RE: **Lot 19 Block 8 Volcano Cliffs Unit 5 SAD 227**
6823 Rimrock Rd. NW
Grading and Drainage Plan
Engineers Stamp Date 9/6/2021 (D10D024)
CO Certification Date: 2/15/2023

Based upon the information provided in your submittal received 3/7/2023, this plan for Certificate of Occupancy cannot be approved until the following comment are addressed.

ENGINEER'S SEAL 	6823 RIMROCK GRADING AND DRAINAGE PLAN Rio Grande Engineering 1606 CENTRAL AVENUE SE SUITE 201 ALBUQUERQUE, NM 87106 (505) 872-0999	DRAWN BY WCVJ DATE 9-02-21 210210083-LAYOUT-B-02-21 SHEET # JOB # 21021083
---------------------	---	--

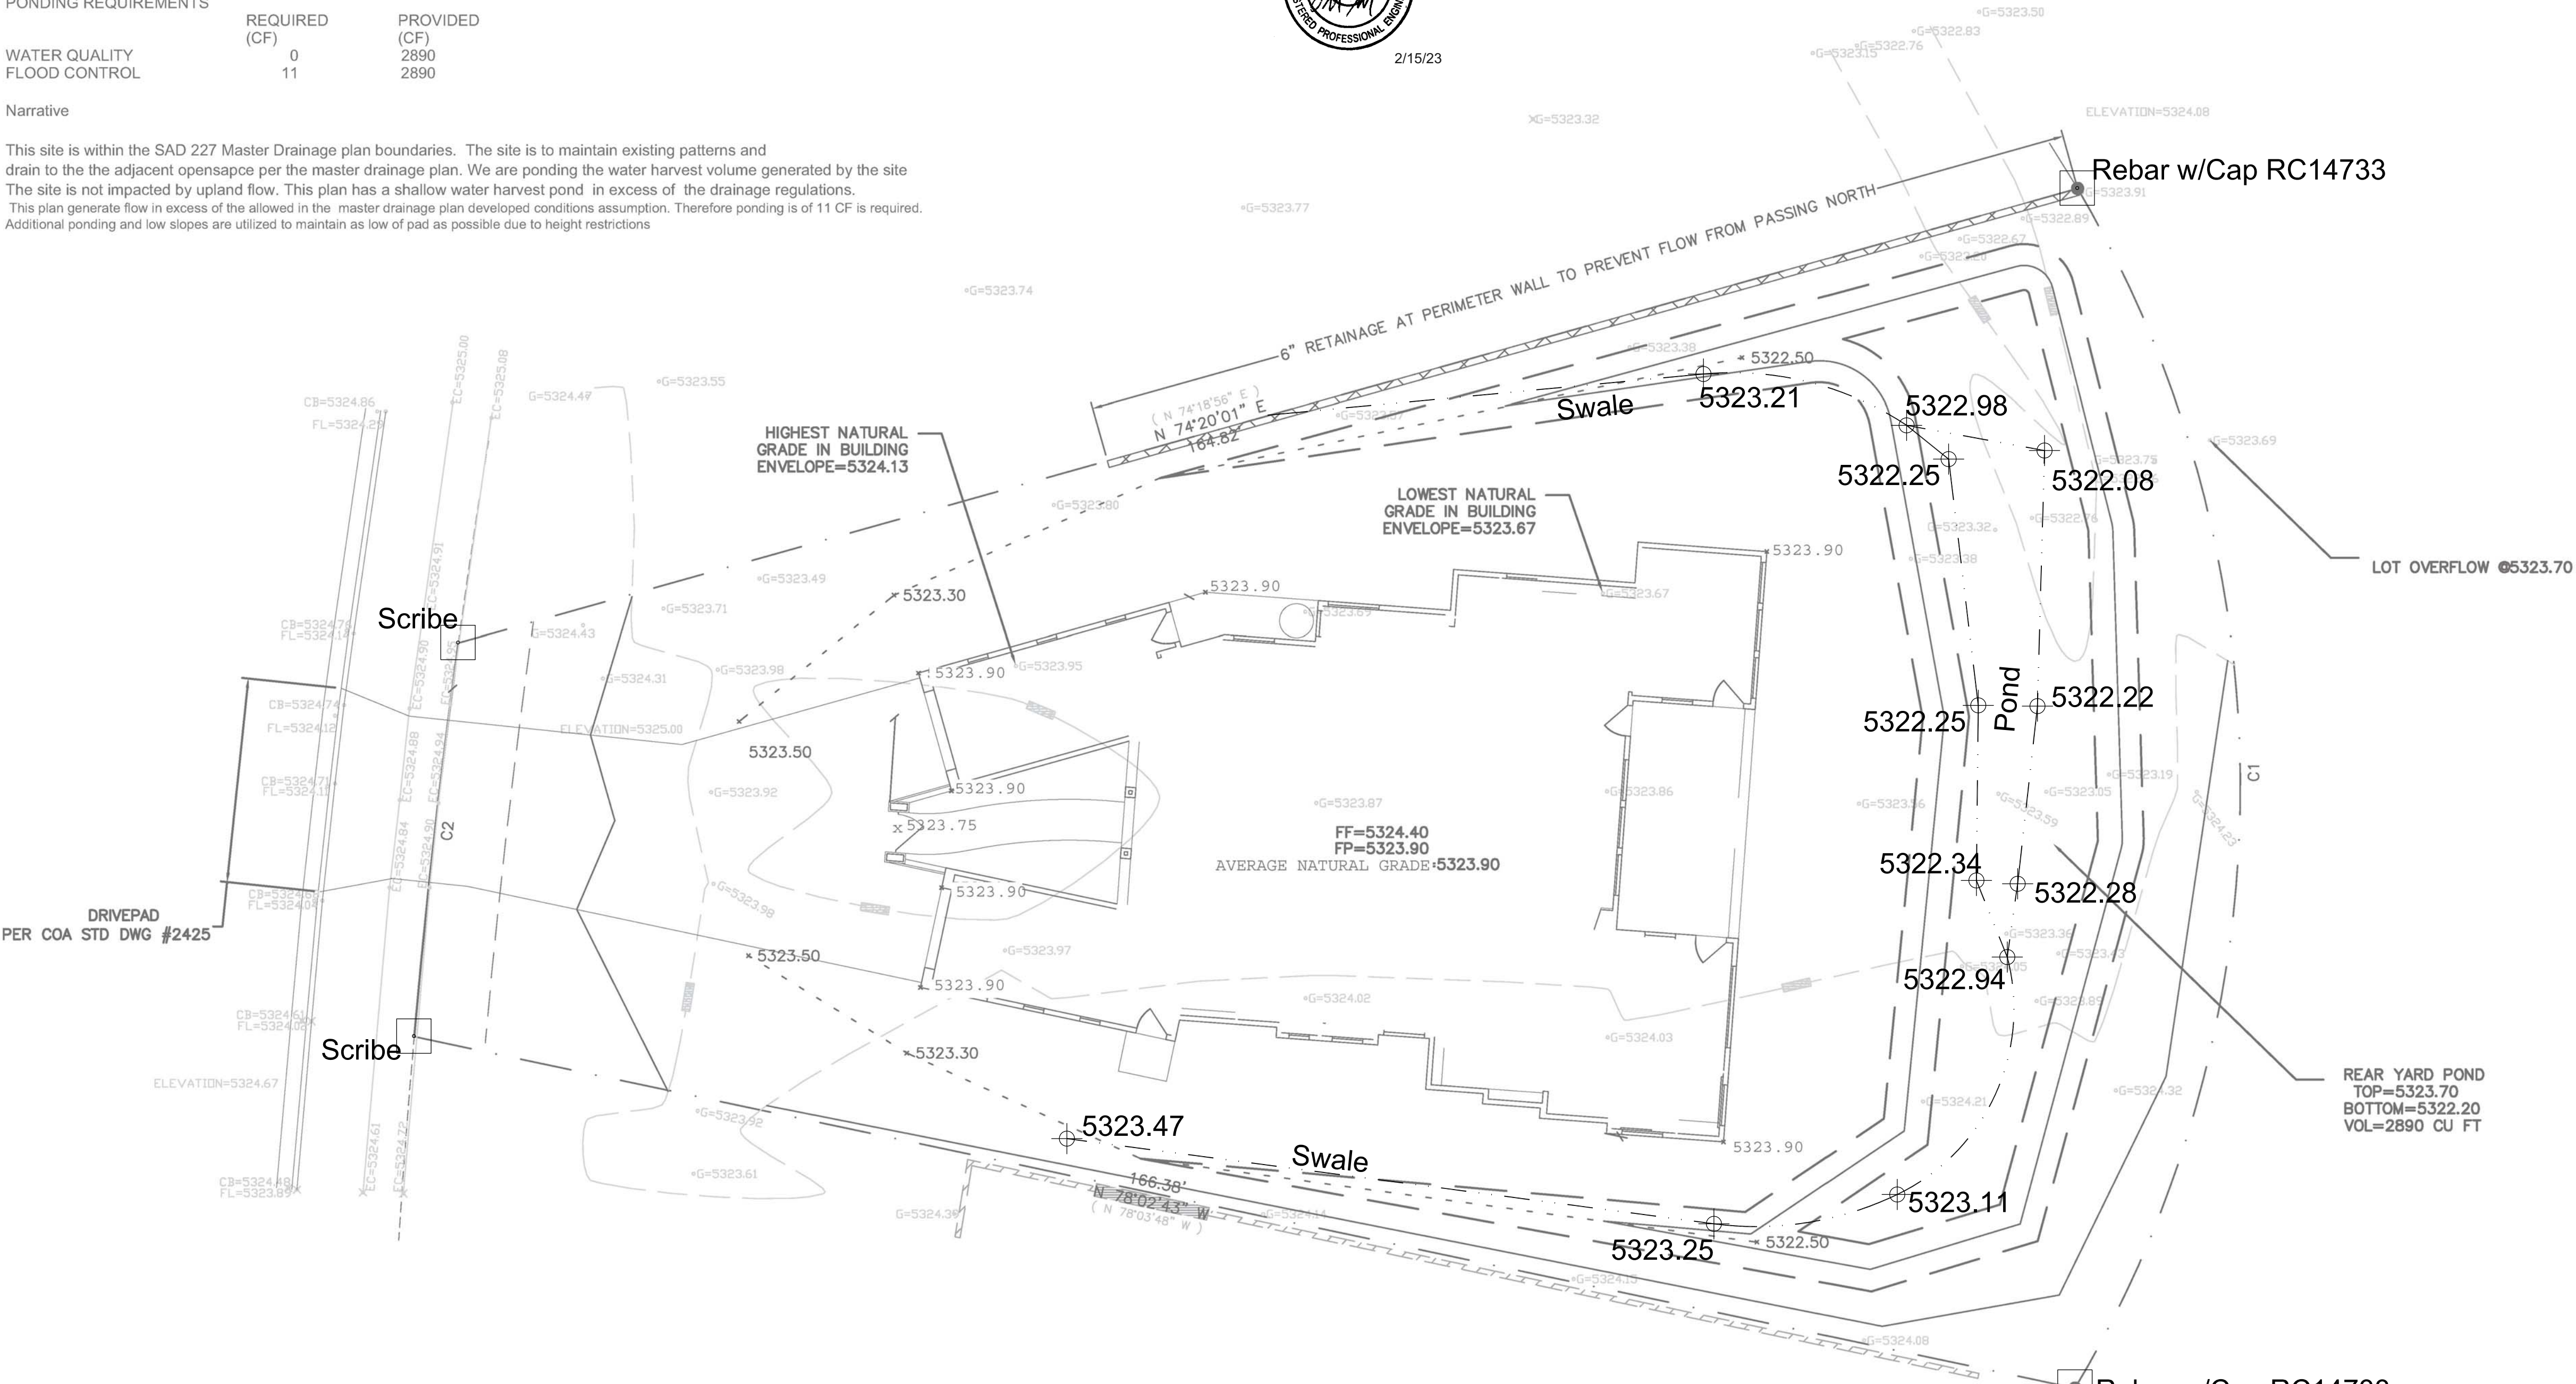
- The port-a-potty needs to be removed.
- Dirt must be removed from the public right of way. It appears dirt was used as a ramp to climb the curb.
